**CITY OF TEMPE
DEVELOPMENT REVIEW COMMISSION**

**Meeting Date: 07/09/2013
Agenda Item: 2**

ACTION: Request for a Use Permit Standard to allow a ten percent rear yard setback reduction and a Development Plan Review consisting of a one-story, +/-8,400 sf. building with associated site and landscape improvements for WARNER & HARL RESTAURANT COMPLEX located at 1639 West Warner Road. The applicant is Sterling Design Associates, LLC.

SITE PLAN
WARNER & HARL
RESTAURANT COMPLEX
WARNER RD. & HARL AVE.
1639 W. WARNER RD.
TEMPE, ARIZONA

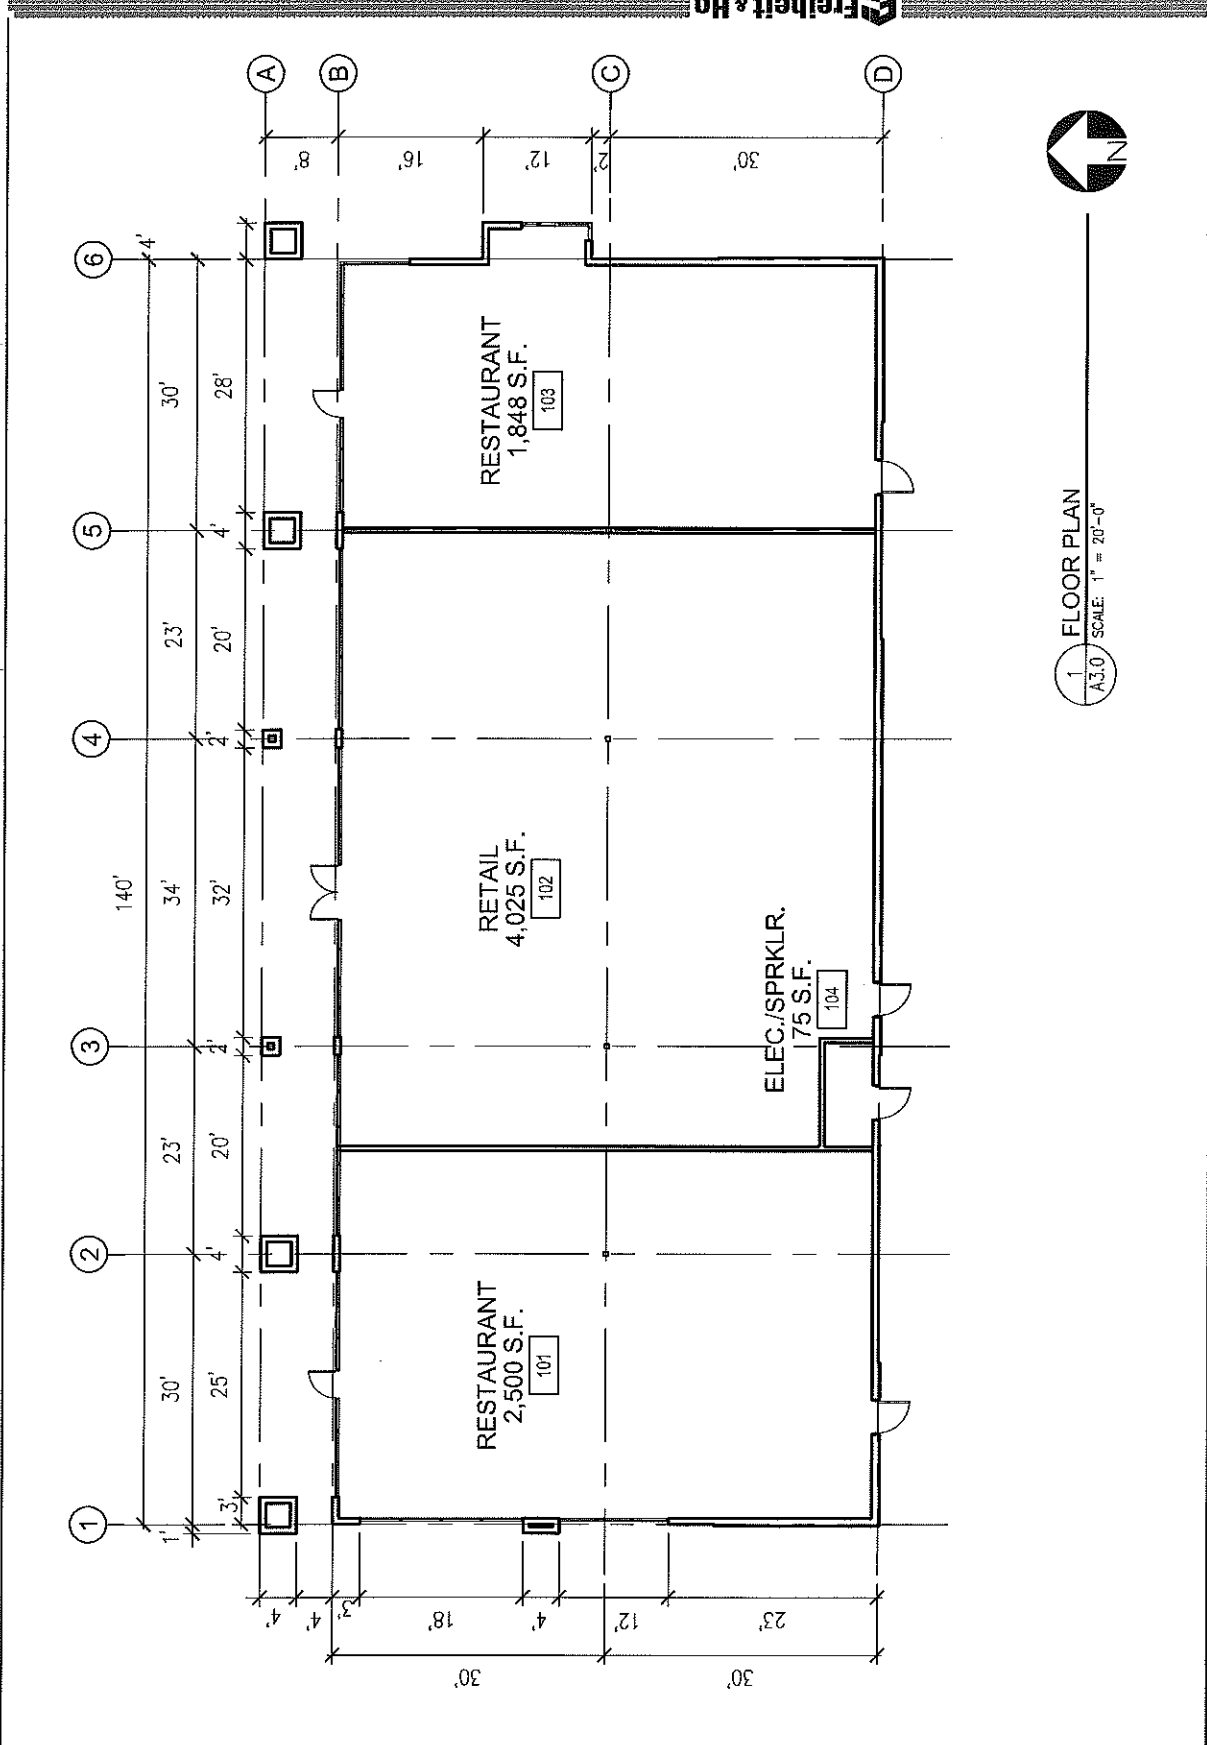
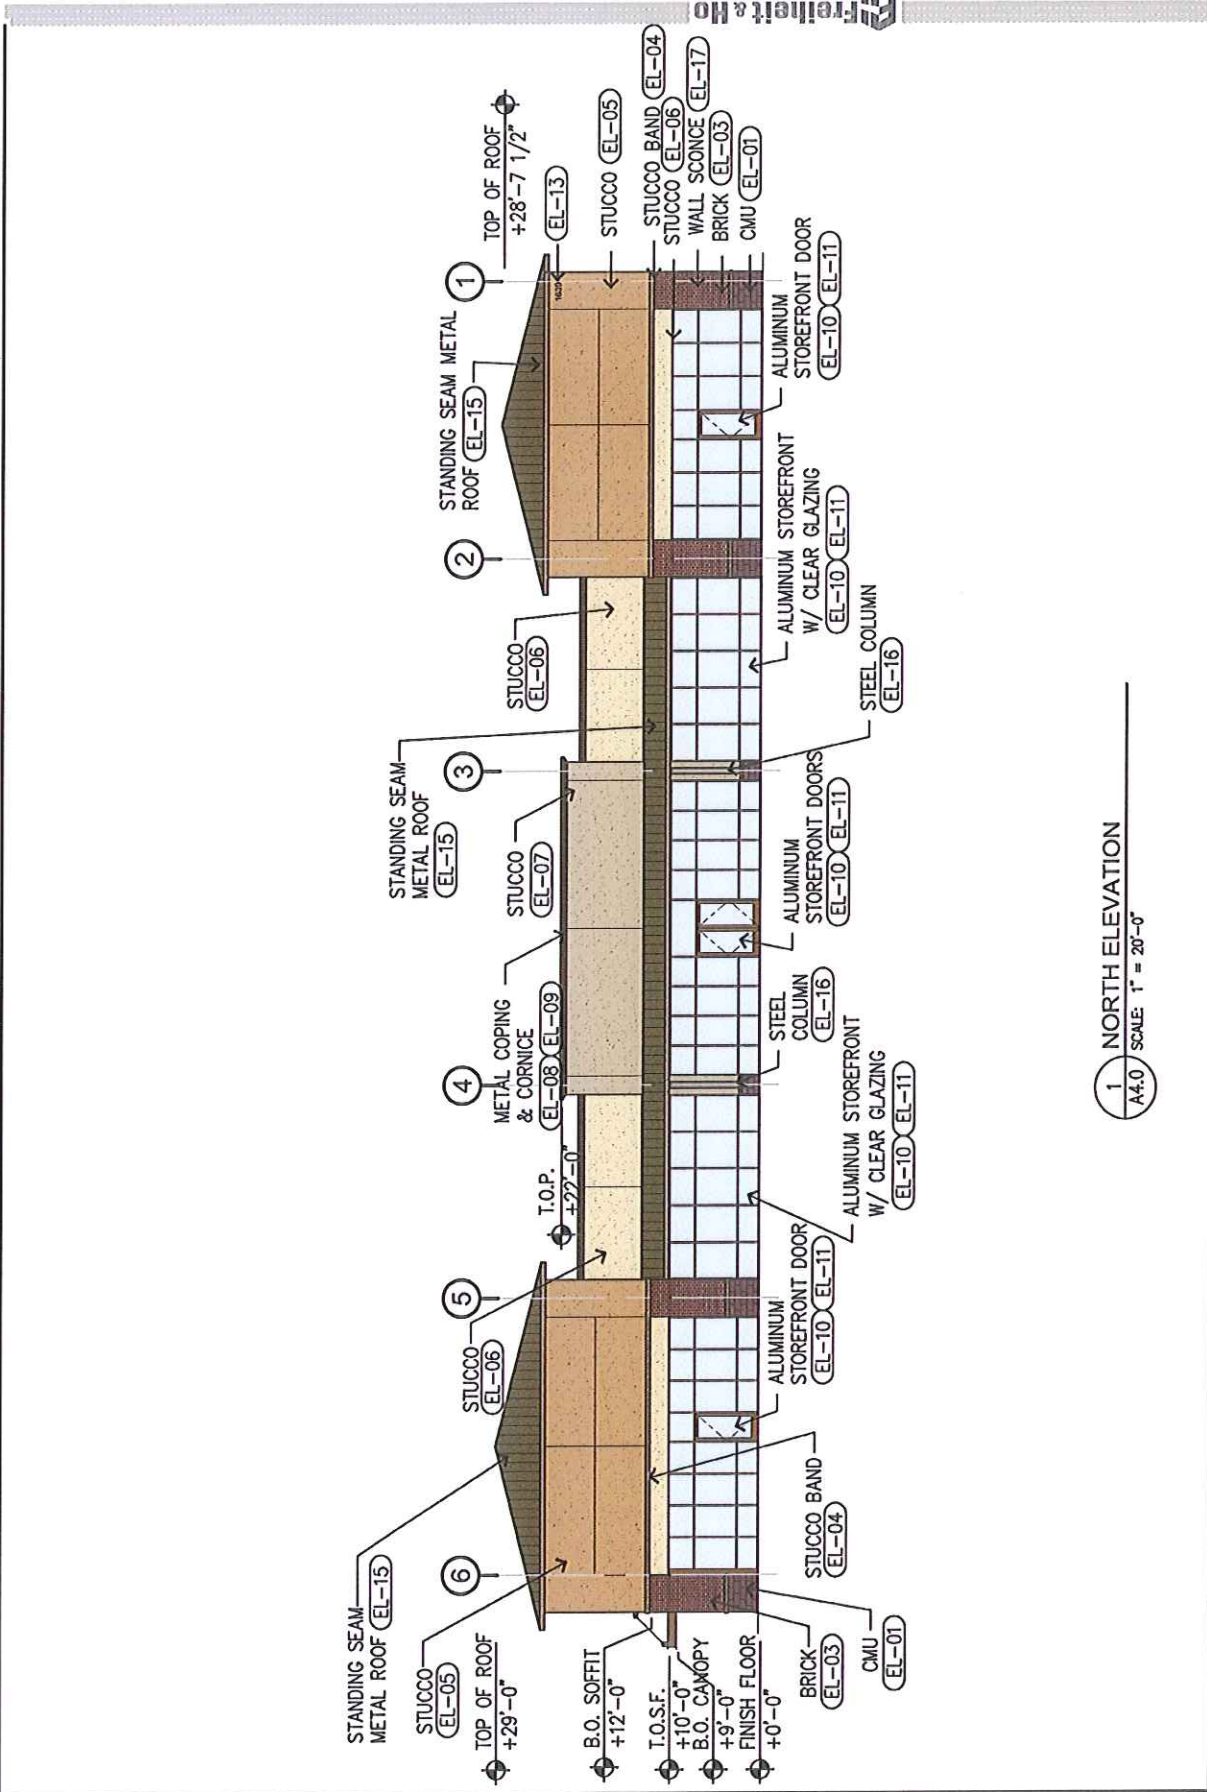
3. Refuse truck circulation through site is required by forward motion. Position of refuse enclosure in northwest site corner is acceptable. Refuse enclosure may be relocated to the southeast site corner upon completion of the south drive aisle through the adjacent property. Refuse enclosure may not be placed at the end of a dead end drive.

5. Supplement berm where needed with a masonry parking screen wall along Warner and Harl so a continuous 3'-0" high parking screen is provided. Finish exterior of screen wall with exterior plaster and paint the building field color.

8. Provide upgraded paving at Harl driveway consisting of unit pavers or uncolored cast in place concrete. Extend upgraded paving in driveway from back of sidewalk bypass to minimum 20'-0" east of the right of way line and from curb to curb at the drive edges.

9. At 90 degree parking, maintain minimum 18'-0" space length including 16'-0" on vehicle pavement and 2'-0" nose overhang over raised curb. Fine tune site layout to avoid front of nose overhang within 20'-0" parking setback facing Harl or within 30'-0" landscape setback facing Warner, and maintain minimum 4'-0" wide clear pedestrian pavement beyond parking nose overhang facing building.

10. Maintain minimum 4'-0" clear pedestrian way between columns and building.
11. Adjust width of walkway along south and west elevations to accommodate a minimum 2'-0" wide planting strip immediately adjacent to the base of the building. Coordinate extent of planting strip with door entrance pavement and drive through sign locations on south elevation.

1 NORTH ELEVATION
 A4.0 SCALE: 1" = 20'-0"

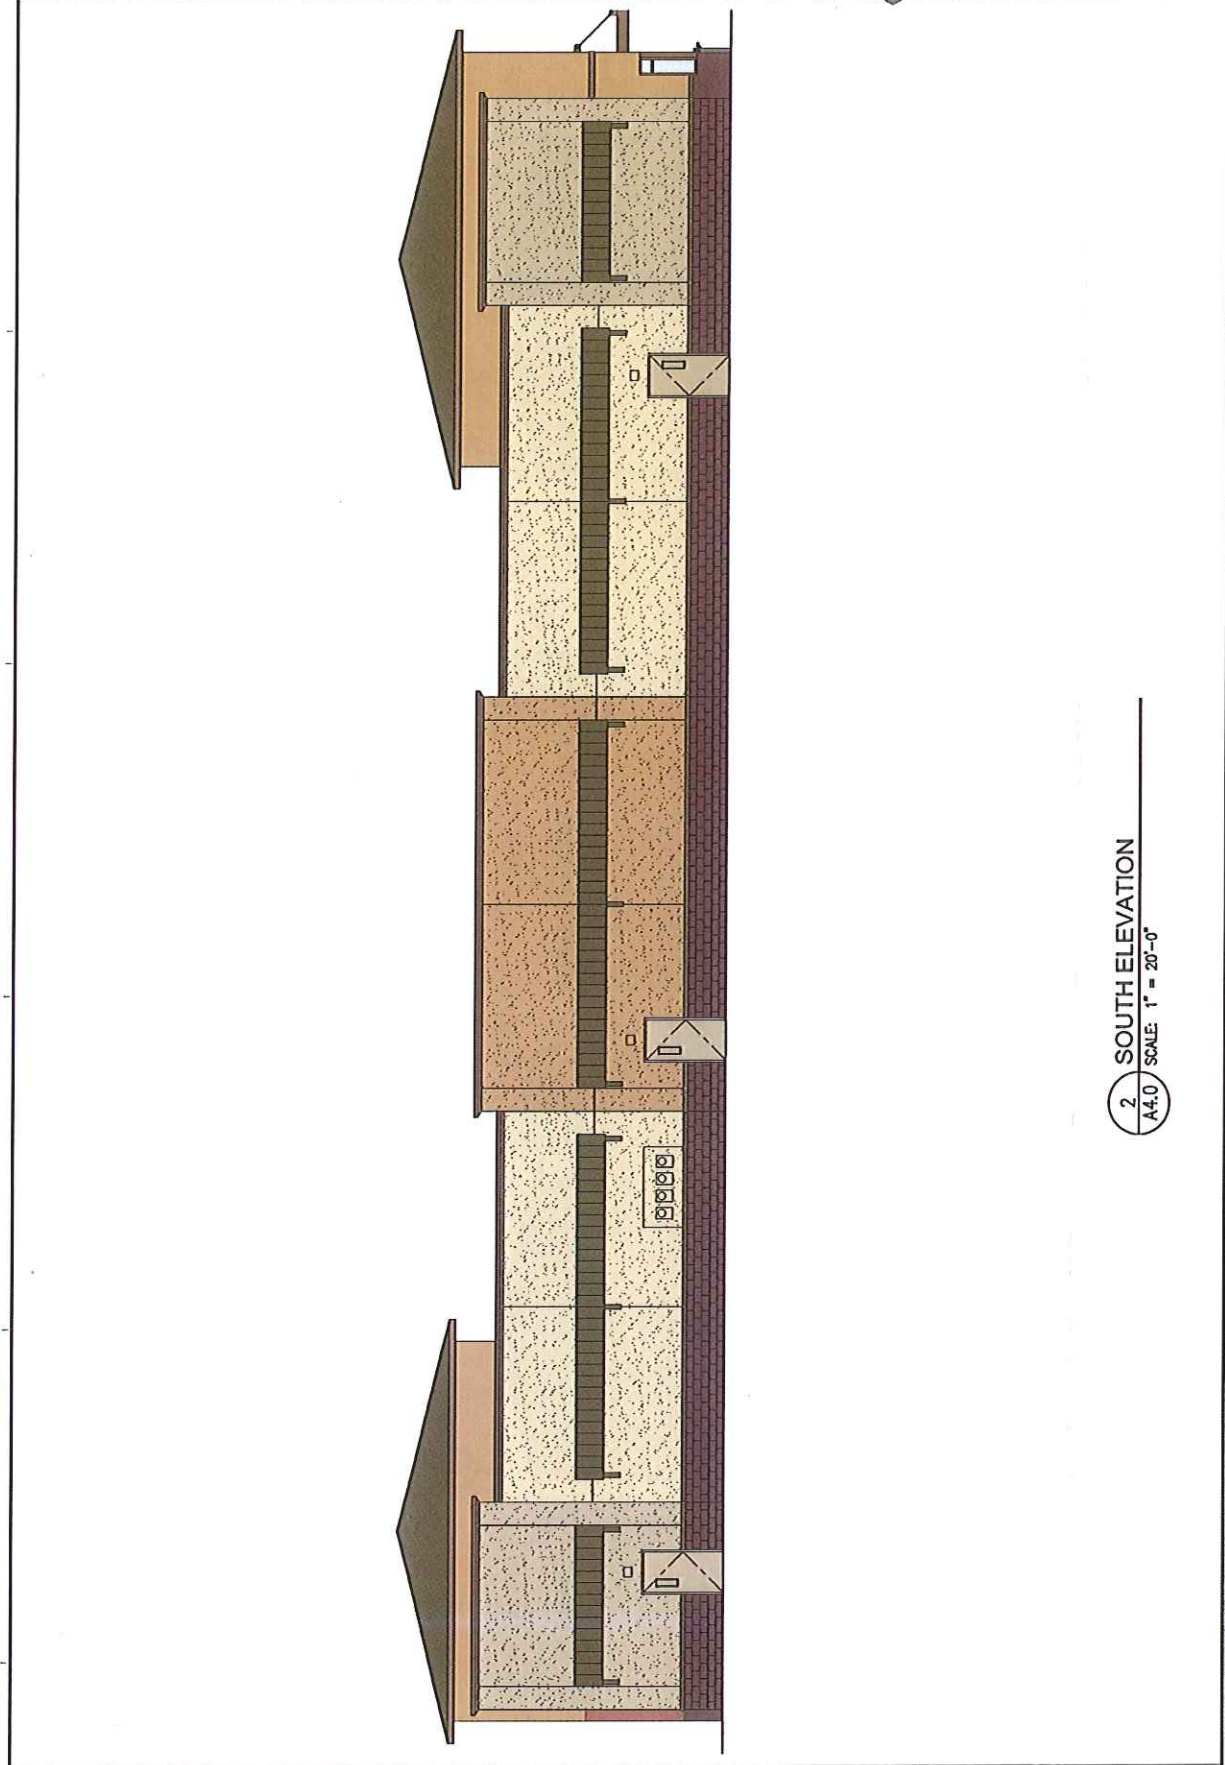
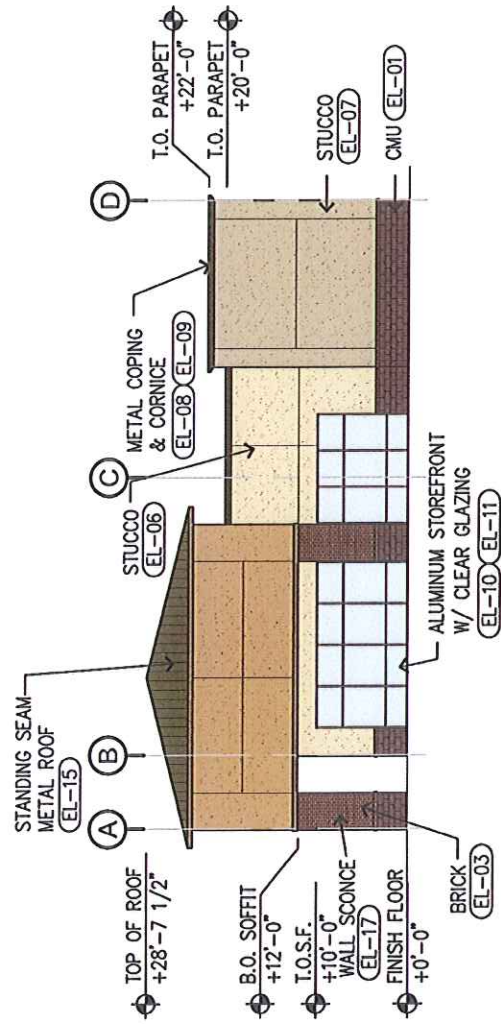
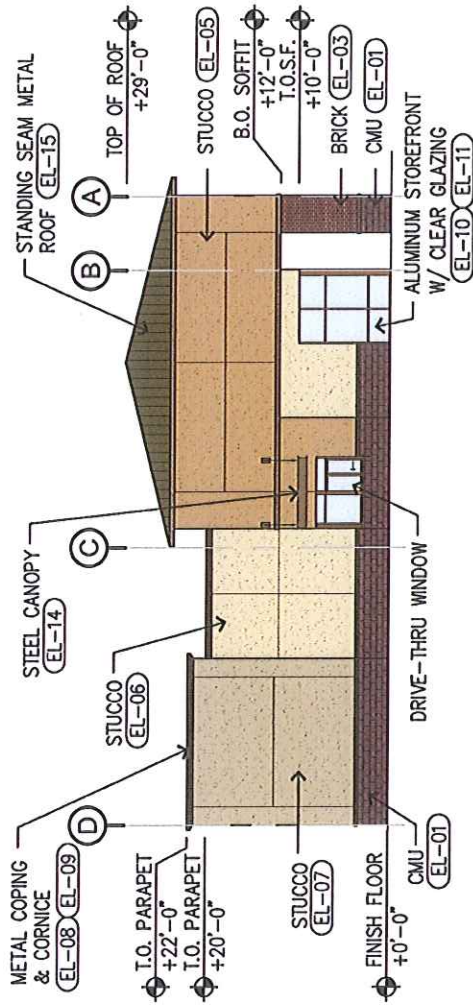
15. Develop detail for shed roofs supported by brackets that are indicated on the south elevation. Provide a minimum 3'-0" projection for shed roofs. Match pitch of hip roofs. Shed roofs are not required to be rain tight but may be a trellis. For exposed elements of shed roofs, provide metal rather than exposed wood construction. Conceal security lights within structure of shed roofs.

16. Move the northwest column and project the west tower toward Harl Avenue so a 3'-0" overhang exists for the west facing glass, similar to as done with the east tower on the east elevation.

17. Provide a minimum 3'-0" deep projecting shed roof above the west glass facing Harl that is south of the west tower overhang. Develop the shed roof detail on the west that is similar to the sheds proposed on the south elevation.

18. Detail a meter bank alcove in the south elevation where indicated. Recess electric meters and panels within the alcove. Do not expose conduit, piping or bus-ways here or elsewhere on the elevations.

LANDSCAPE PLAN

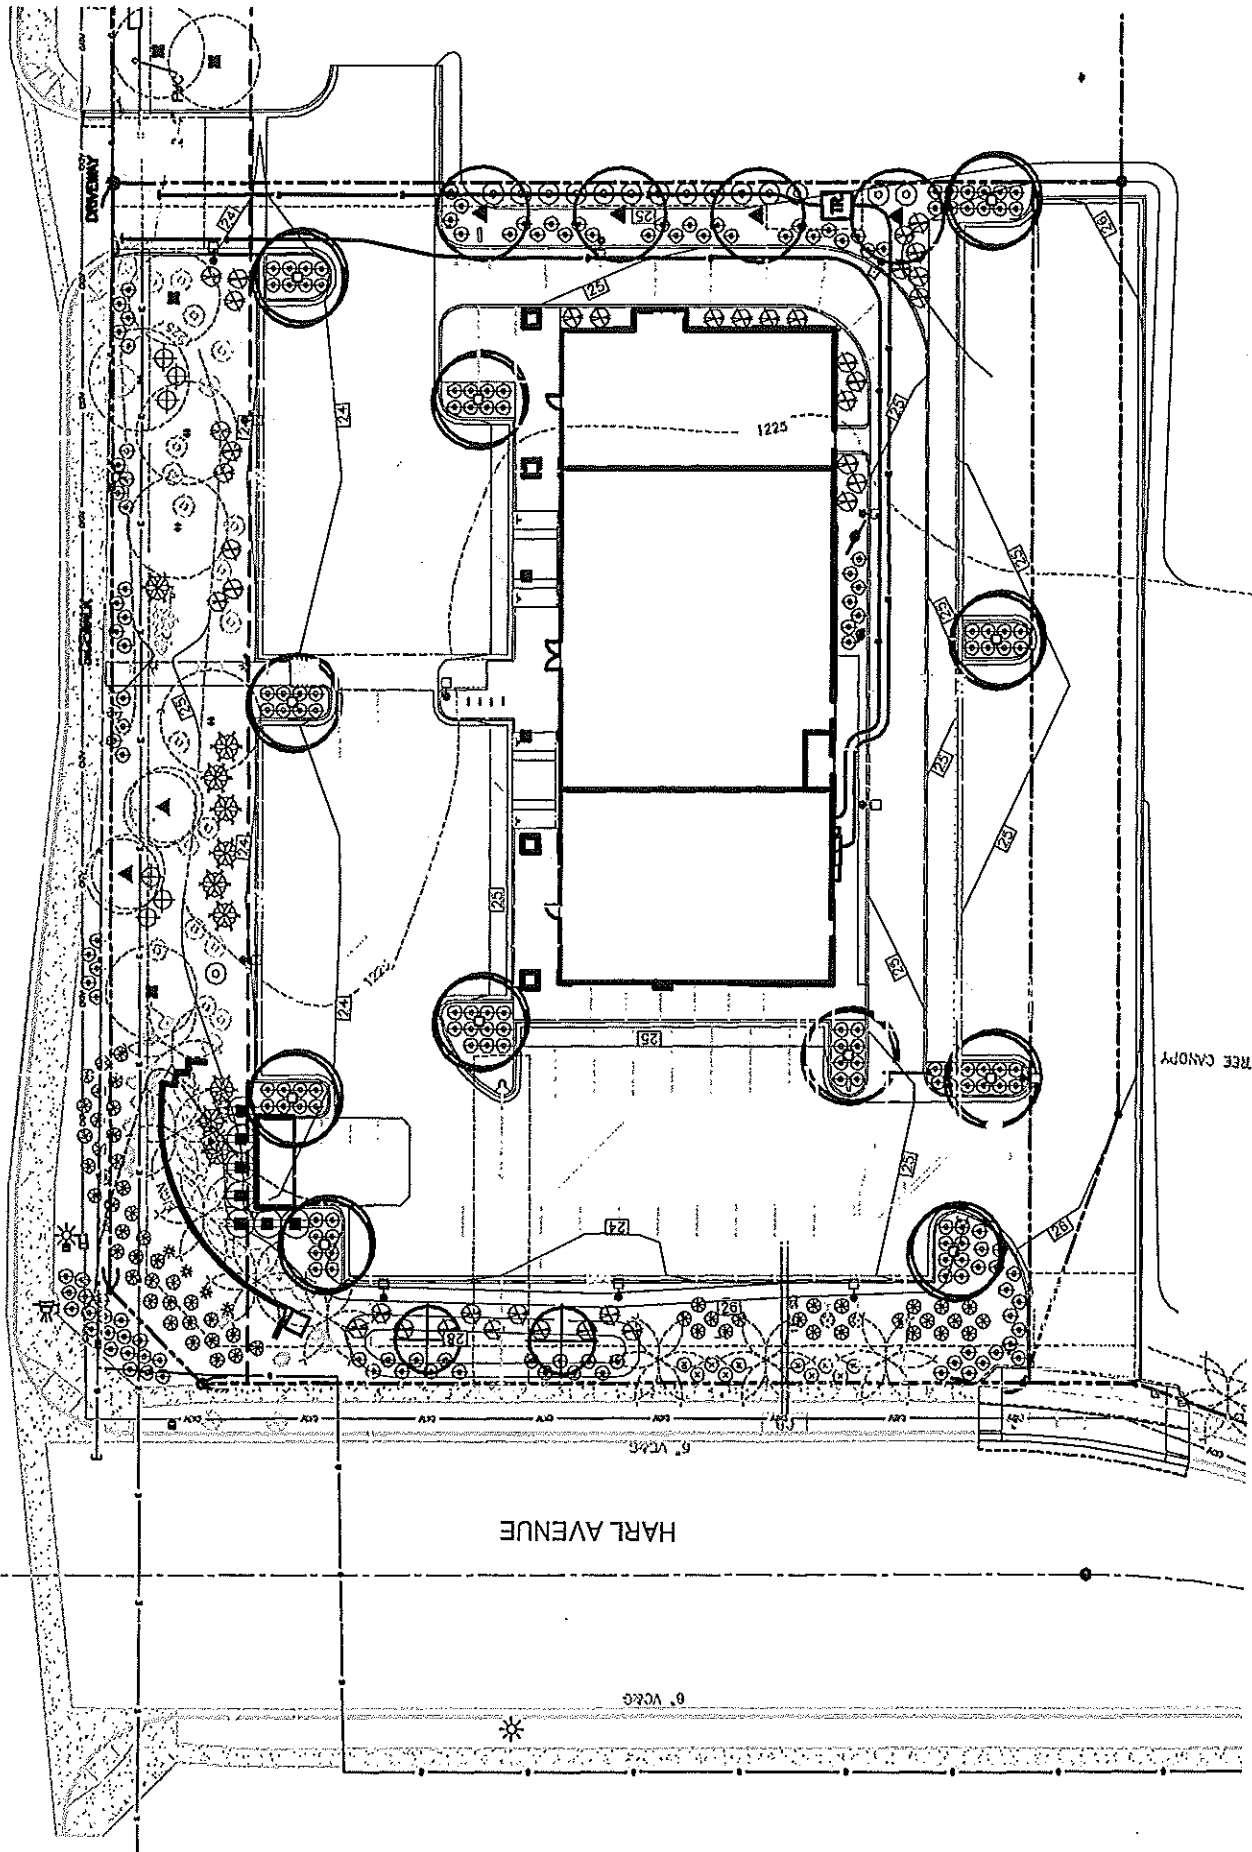
1. Provide five *Cercidium praecox* along the east property line adjacent to the east building elevation rather than four. Provide minimum 30" box size at installation for these five trees.

25. Identify species of the existing trees, palms, shrubs and groundcovers to remain on site and in adjacent off-site street right of way. Include existing landscape in the plant schedule and individually identify existing plant types by symbol on plan, as is done for the plants proposed for installation.

26. Provide a landscape strip at the base of the west and south building elevations. Plant with low groundcovers and vines. Select plants that are thorn-less and thrive in direct and reflected sunlight. Detail vertical metal lattice elements secured to the exterior plaster wall surface. Coordinate position of metal lattice to allow climbing vines to grow on the lattice attached to the south and west elevations.
